ewed by UCD: D2/14/2021 9:53:06 AM S. Department of the Interior UREAU OF LAND MANAGEMENT		Sundry Print Rep 12/13/20
Well Name: SERENDIPITY COM	Well Location: T26N / R13W / SEC 26 / NWSE / 36.45644 / -108.18668	County or Parish/State: SAN JUAN / NM
Well Number: 1	Type of Well: CONVENTIONAL GAS WELL	Allottee or Tribe Name:
Lease Number: NMNM33031	Unit or CA Name: E2, FRCL	Unit or CA Number: NMNM91285
US Well Number: 300452567900S2	Well Status: Inactive	Operator: MUSTANG RESOURCES LLC

Sundry ID: 2642618

Type of Action: Plug and Abandonment Time Sundry Submitted: 08:02

BLM FLUID MINERALS P&A Geologic Report

Well No. Serendipity Com #1 (API#	Location	1650	FSL	&	2310	FEL	
Lease No. NMNM-33031	Sec. 26	T26N			R13W		
Operator Mustang Resources, LLC	County	San J	San Juan State New Mexi		lexico		
Total Depth 5120'	Formation	Fruitland	l coal (pre	viously Ga	allup)		
Elevation (GL) 6205'		Elevation (KE	B) 6218'

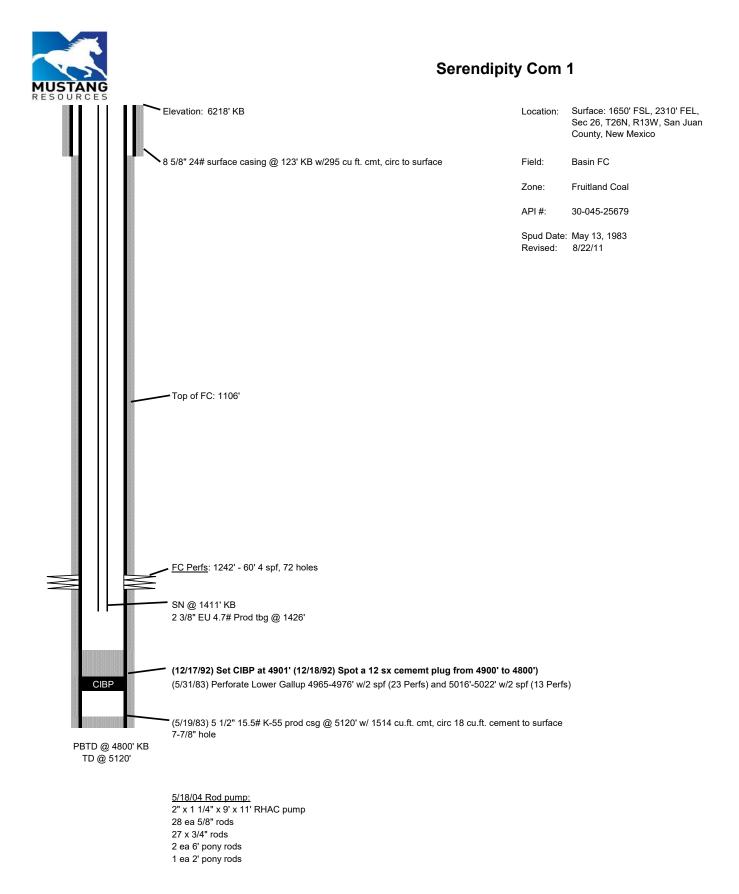
- BLM picks for the top of the Cliff House and Chacra formations vary from Operator picks.
- Operator previously set CIBP at 4901' and spotted cement plug 4900' 4800' when well was plugged back to the Fruitland in 1992.
- Add a plug to cover the Cliff House at 2030'.
- Bring the top of Plug #2 (Pictured Cliffs) up to 1241'.
- The plugs proposed in the P&A procedure, with changes as recommended above, will adequately protect any freshwater sands in this well bore.
- Fruitland perfs 1242' 1260'.

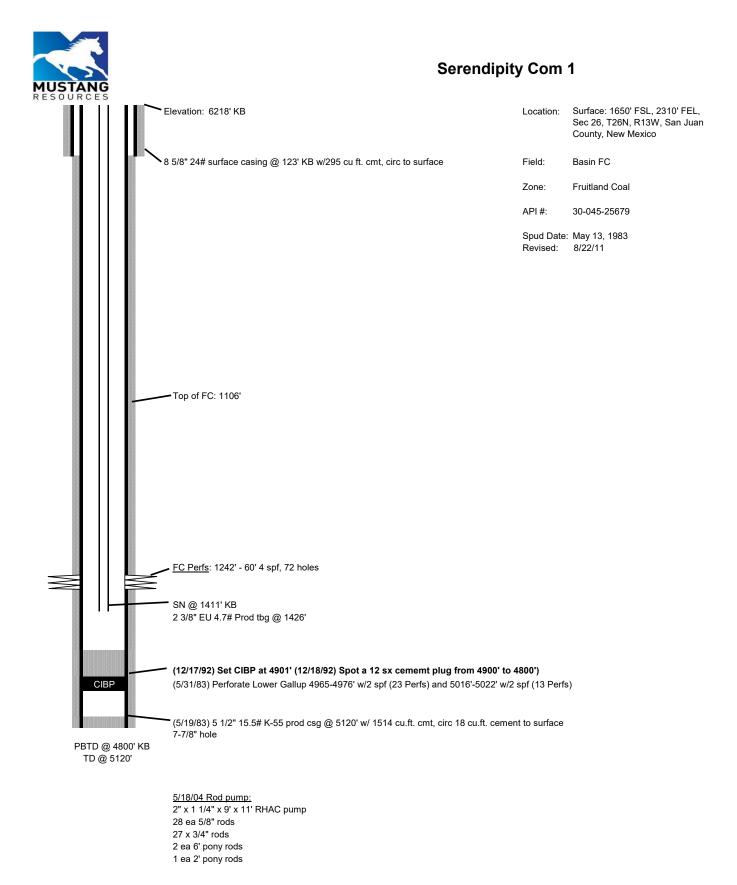
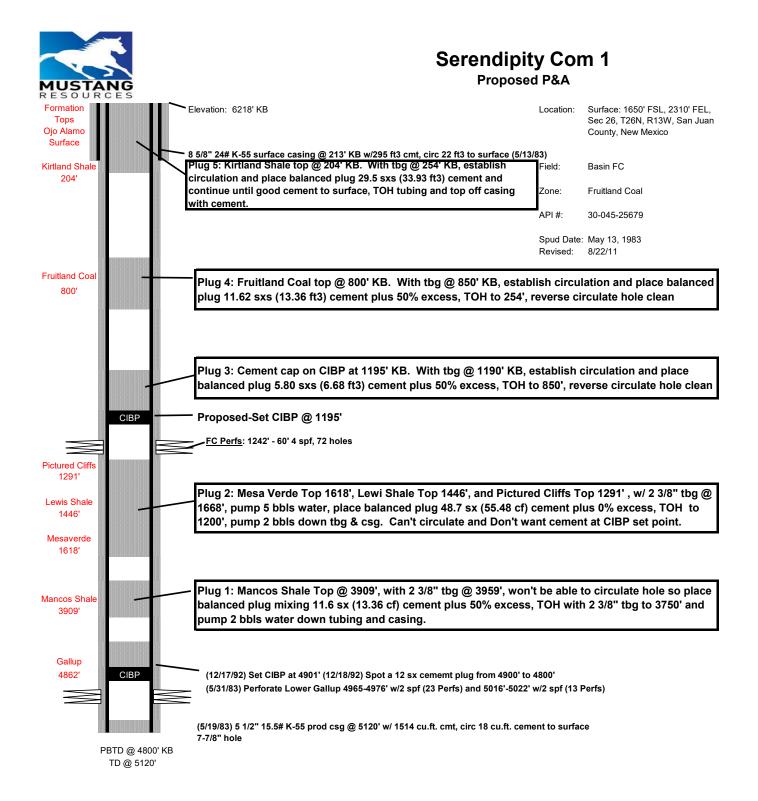
- 1. Plugging operations authorized are subject to the attached "General Requirements for Permanent Abandonment of Wells on Federal and Indian Lease."
- 2. Farmington Office is to be notified at least 24 hours before the plugging operations commence (505) 564-7750.
- 3. Before or within 30 days after completing work, Mustang Resources LLC must contact a Farmington Field Office surface inspection staff to schedule a reclamation onsite.
- 4. The following modifications to your plugging program are to be made:
 - a) Add a plug to cover the Cliff House formation top at 2030 feet.
 - b) Bring the top of Plug no. 2 (Pictured Cliffs) up to 1241 feet.
 - c) For Plug no. 5, set tubing a minimum of 50 feet below surface casing at 213 feet before circulating cement.

You are also required to place cement excesses per 4.2 and 4.4 of the attached General Requirements.
